**PROPOSED DUALLING OF MAIN ROAD 201 (R301), PAARL, WESTERN CAPE.
GNEC Code: 20565
DEA&DP Ref: 16/3/3/6/7/1/B3/28/1156/19**

Your invitation to provide comment on the above as part of the first Public Participation Process running from 24th February 2020 to 27th March 2020 has reference.

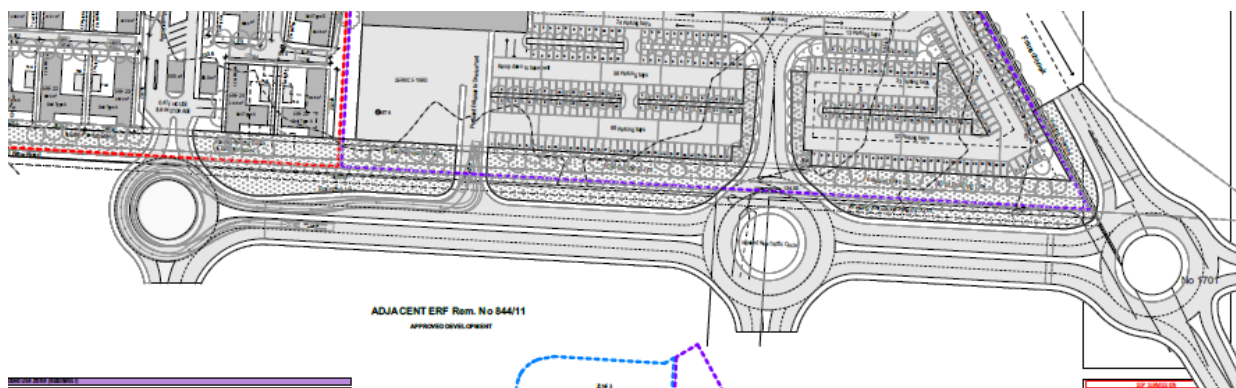
However, the list of Specialist Studies does not include any traffic study to support these statements. It would have been expected that a Traffic Study would be essential to assess and answer the following:

- The upgrade proposals make provision for the consolidation or closure of access points and to maintain others. The closure of OP5252 at km 60.770 will be the closure of a provincial road and not an access (driveway). This road currently provides access to individual properties to the west. How will access to these properties be maintained with such closure?
- Will OP5252 be de-proclaimed as a provincial road and if so, what process will be followed?
- What would the traffic impact be at the major accesses after redistribution of traffic from existing accesses that will be closed?
- Although the letter refers to future traffic volumes, the intersections and access type of control remain unchanged from priority-control. The increase in traffic would suggest

possible signalisation or roundabout-control at these points. Was this assessed in the upgrade proposal?

Extract from Bretagna SDP

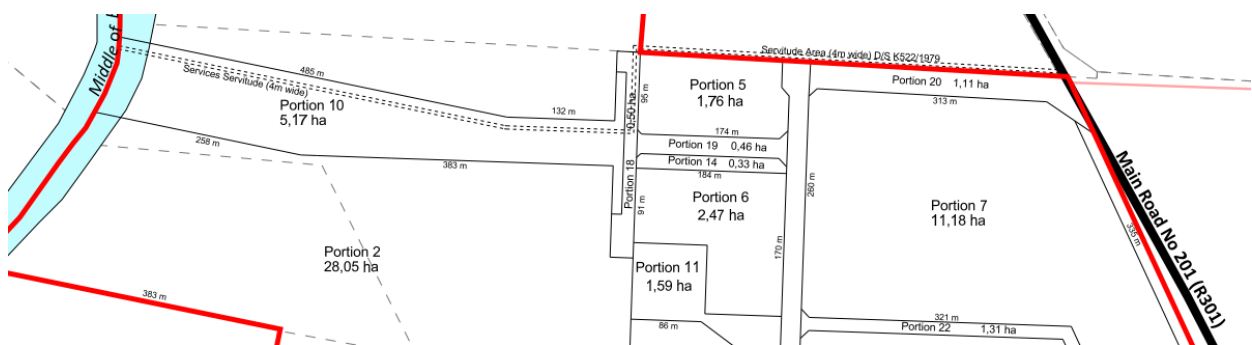
- Similarly to the above, the intersection point of the access at km 61.650 will be incorrect if the conditions of approval of the developments on erf 26158 and Farm 844 Portion 11 would apply. According to the Drakenstein Municipality SDF for this area, this access will become a Class 3 municipal road of which the road reserve will be located completed on Farm 844 Portion 11.
- The alignment of this Class 3 intersection is shown below as per an extract from the Bretagna approved SDP and also from the Fraaigelegen approved SDP (Portion 20).

- Even if the WCG is not responsible for the implementation of certain individual developments' approval conditions, the implementation of major road network of the municipality should be acknowledged to prevent abortive work. How will this be recognised?
